DC/18/2076 – “Variation of condition 1 of previously approved application DC/18/1046 (Minor- Material Amendment to DC/15/2493 to facilitate alterations to the approved site layout and approved designs) to alter the height of the roof.

The Paddock, Micklepage, Nuthurst Street, Nuthurst

RESOLVED The Parish Council strongly objects to this application.

Annex 1: to illustrate retention of a fourth upstairs bedroom and en-suite bathroom contrary to policy 7 of the Neighbourhood Plan

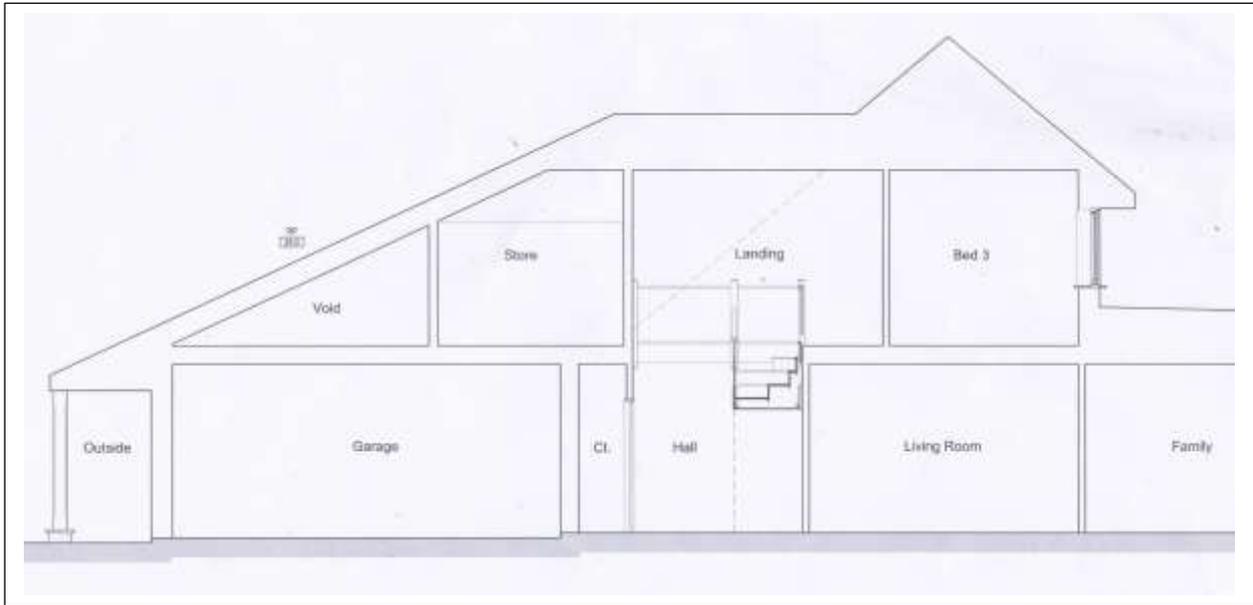
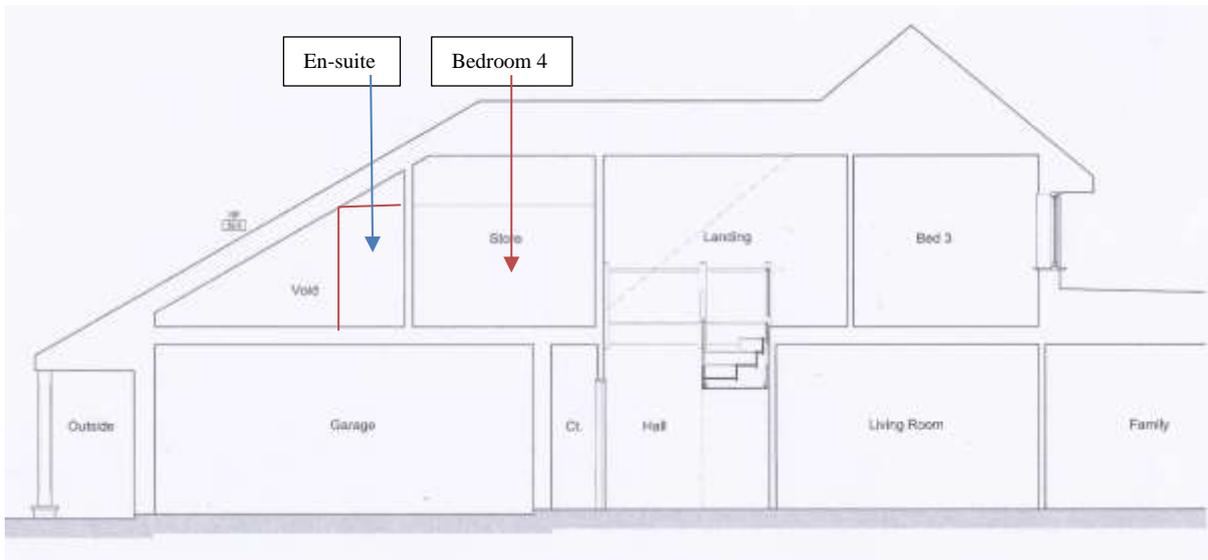
These sections clearly show that, by increasing the slope of the roof above the garage and therefore the ridge length of the roof, the “store” in the approved DC/18/1046 becomes a bedroom in the proposed DC/18/2076 and almost identical in floor area and height to bedroom 3. It also shows that the en-suite bathroom, as built in the refused DC/17/2524, can be retained. This gives the houses 4 upstairs bedrooms which is contrary to policy 7 of the Neighbourhood Plan.

Connells marketing material: first floor plan

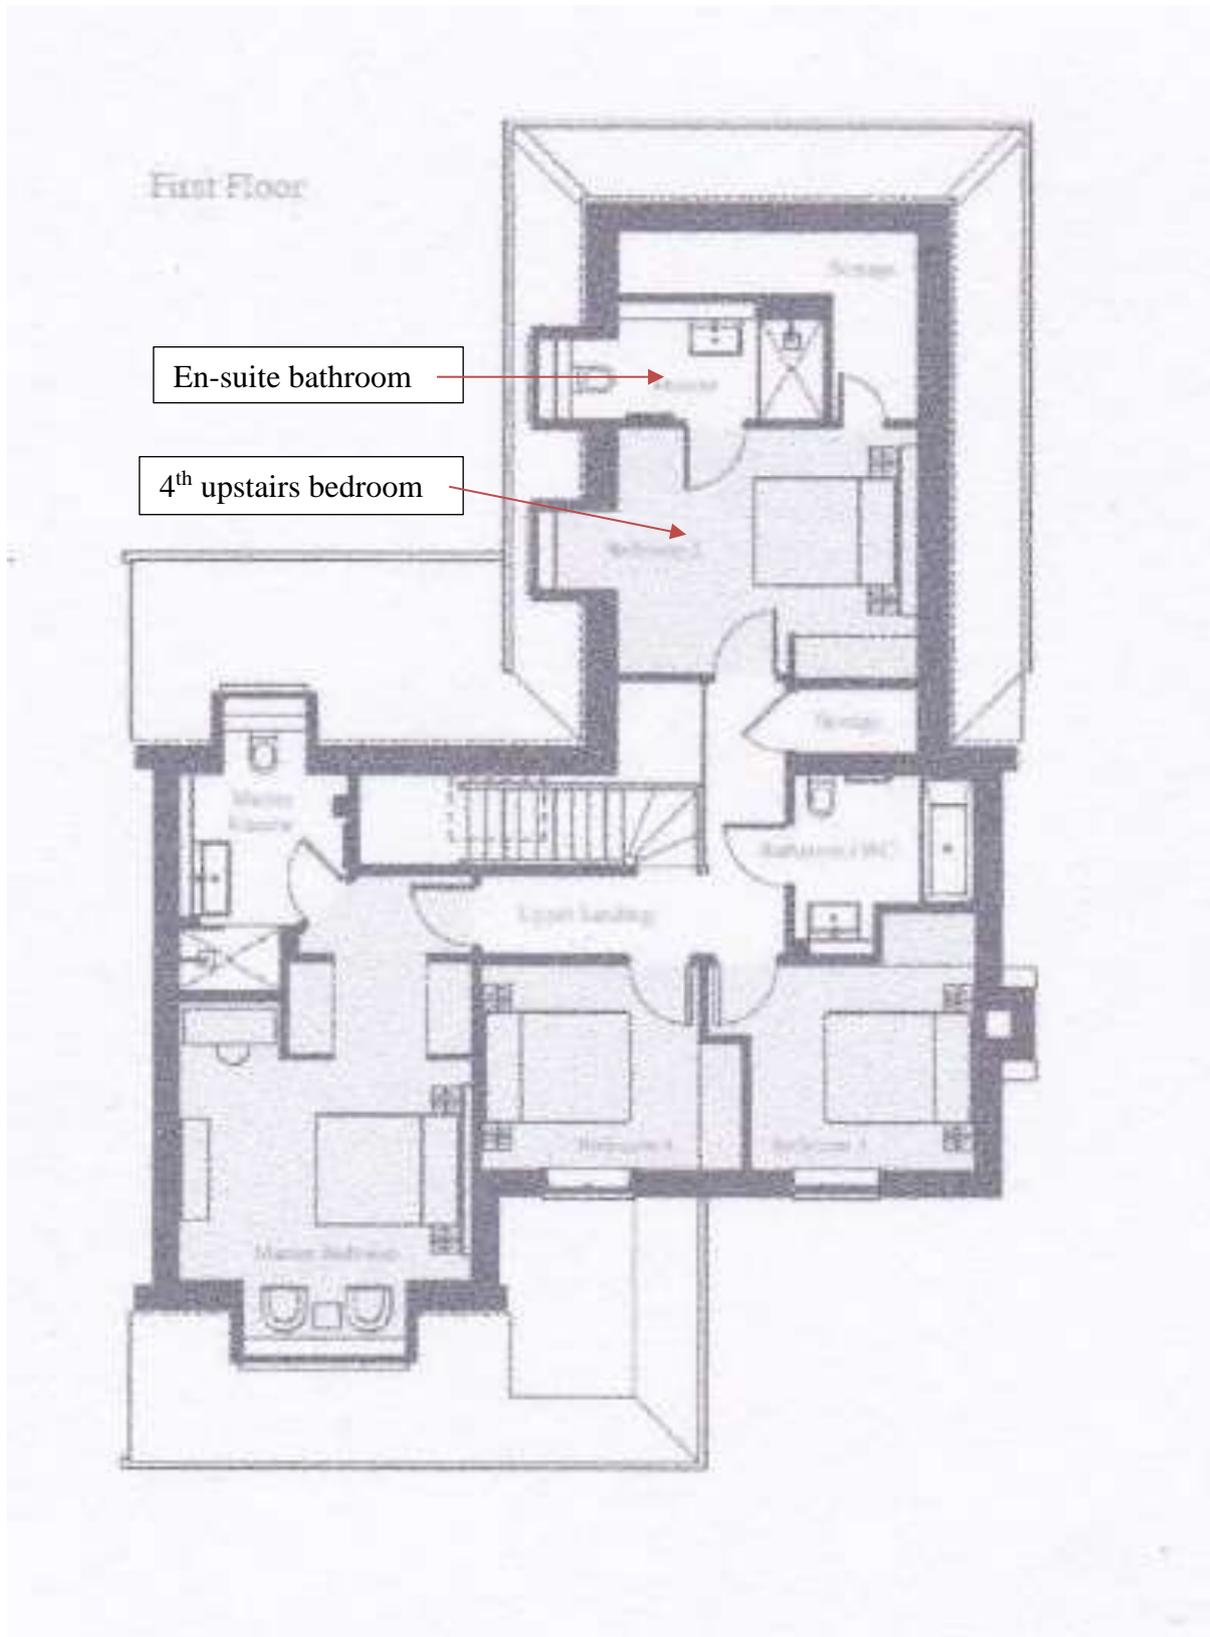
The first floor plan from the Connells marketing material for the houses as built shows the bedroom and en-suite bathroom in the roof above the garage. DC/18/2076 seeks to achieve the same.

Annex 2: to illustrate the increased massing contrary to policy 10 of the Neighbourhood Plan DC/18/1046 - approved

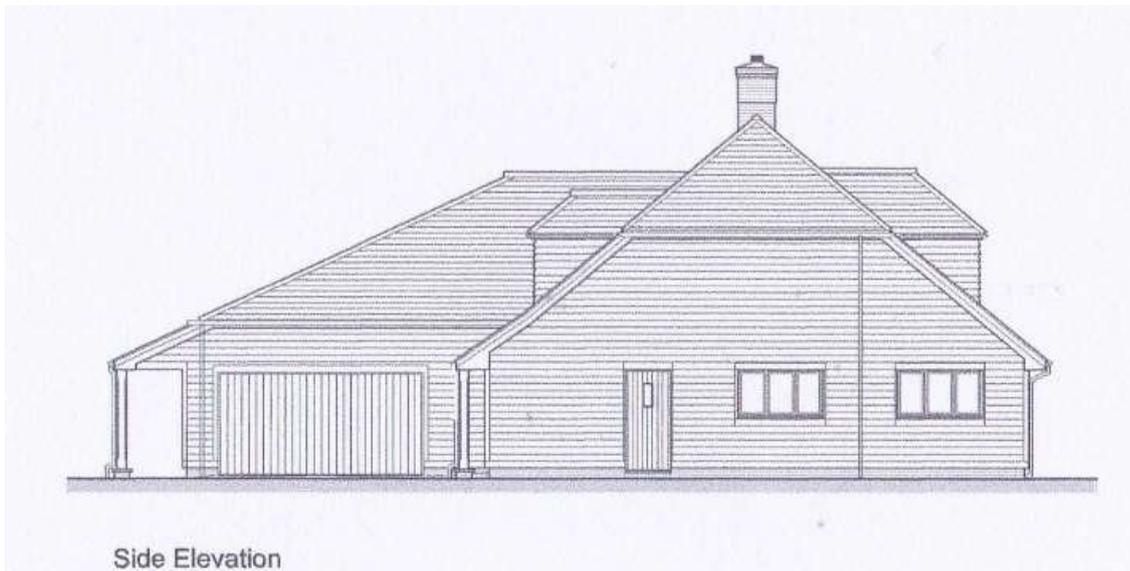
These elevations clearly show the increased massing of the roof above the garage proposed in DC/18/2076, compared to that in the approved DC/18/1046. This increased massing contravenes Policy 10 of the Neighbourhood Plan.
